# SKEP III Home Office Support Site Visit Report

Consultant	Wahib Medanat Consultant Engineer	Rep No.	13-25062022
Contractor	Derar Saraireh & Sons for Engineering & Contracting	Tender No.	(11/2019/USAID/SKEP/3/S) Schools for a Knowledge Economy Project (SKEP) - Phase (3) Package (1, 2)
Site Name	Khadija Bint Khwailed Basic Mixed School- Shouna Janoubia	Day/ Date	Sat. 25/06/2022
Duration of Project	450 Calendar Days	Total Project Budget	9,789,417.840 JD

(Figure: 13)

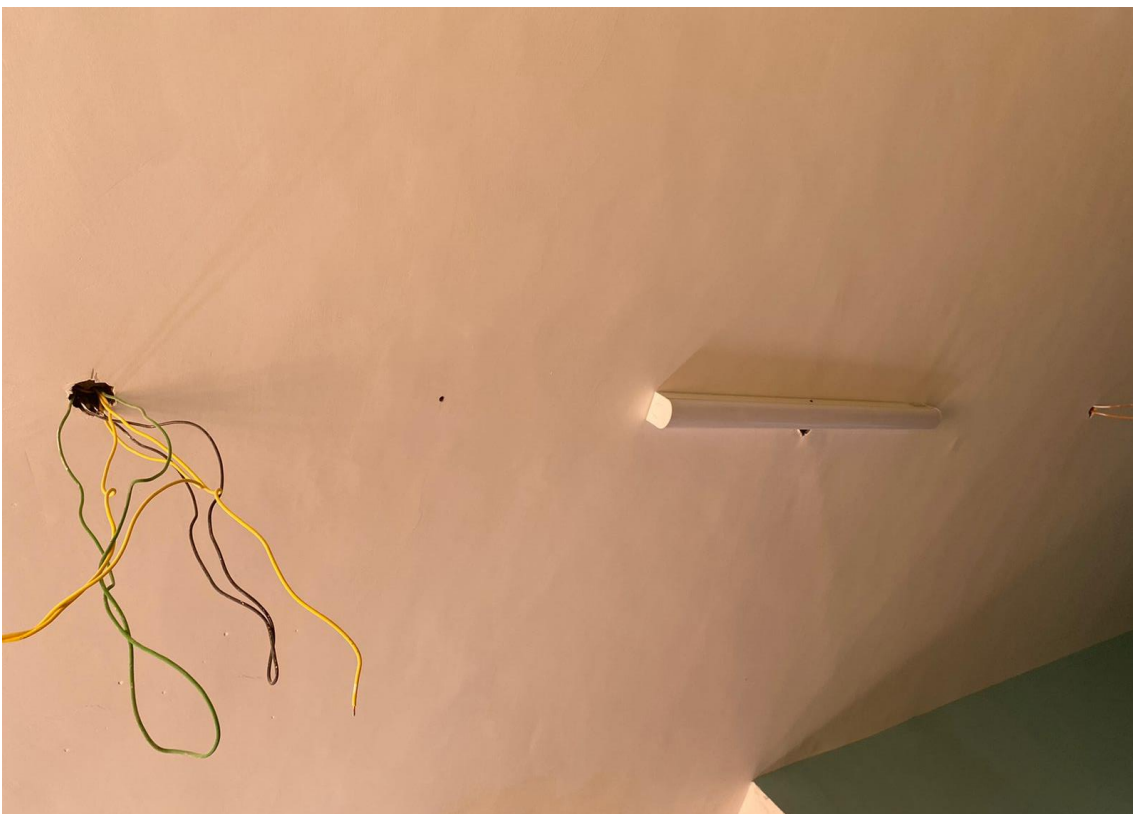
The team observed that there is some waving in the plastering and painting at the corridors and ceilings along with openings at the ceiling. The Contractor was requested to rectify waving and close these openings
